The City of Spartanburg Board of Architectural Design & Historic Review

AGENDA

RE: Certificate of Appropriateness for Major Works
Address: 232 Hydrick Street (TMS: 7-12-14-166.00)
Historic District: Hampton Heights Historic District
Zoning: R-8 SFD (Single Family District)
Owner: City of Spartanburg
Applicant: Oak and Ave Property Group

Request: The applicant is seeking approval to construct a new one-car garage at the end of the driveway. The applicant is also requesting to replace the two side-facing attic windows on the existing home.

Front Wall Elevation

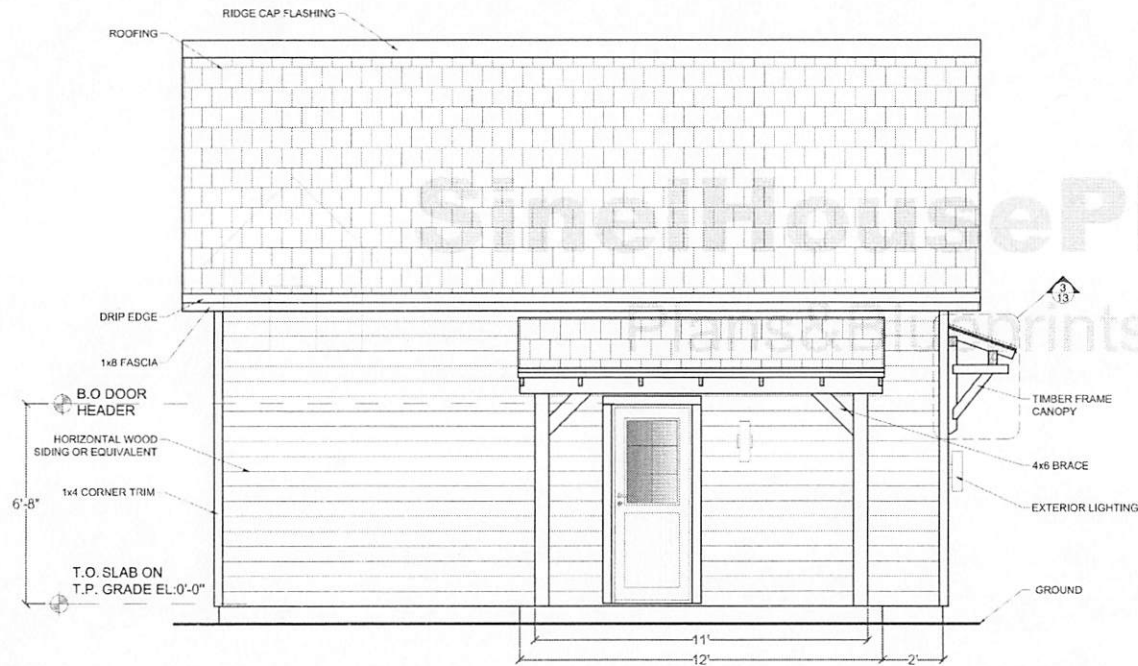
1. Applicant to provide samples/submittals of the siding, windows, garage door, and roof materials for staff review
2. Applicant to revise plans to incorporate architectural shingles instead of the proposed metal/tin roof.
3. Applicant to revise coverings over garage door and side door to align with minimal traditional architecture style of primary structure.

Detached Garage - Build a new one car garage at the end of the driveway on the left side of the house. See attached floor plans for dimensions. Carriage style doors will face the street and shingle siding will match those on the house. Roof will be metal/tin.
